ADDENDUM NO.04**DATE: 11/04/21**

'Matilda Torres High School, Toros Stadium'
Matilda Torres High School
16645 Road 26. Madera, CA 93638

DARDEN PROJECT NO. 0622.4
DSA File Nos. 10-C3
DSA APPL. NO. 02-118396

The following additions, deletions, and revisions to the SHEETS and Project Manual are hereby made and do become a part of these Contract Documents.

AD3-ID-5

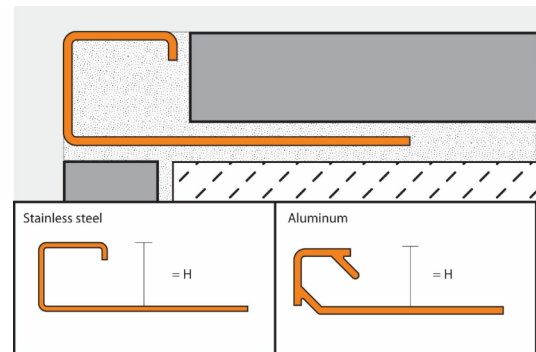
a. Schluter Strip requirements at outside corner transitions clarified.

Provide Schluter QUADEC finishing and edge profile at all outside corners. Finish to be Aluminum Satin Anodized.

1. Replace Sheet ID-5 with attached exhibit AD3-ID5
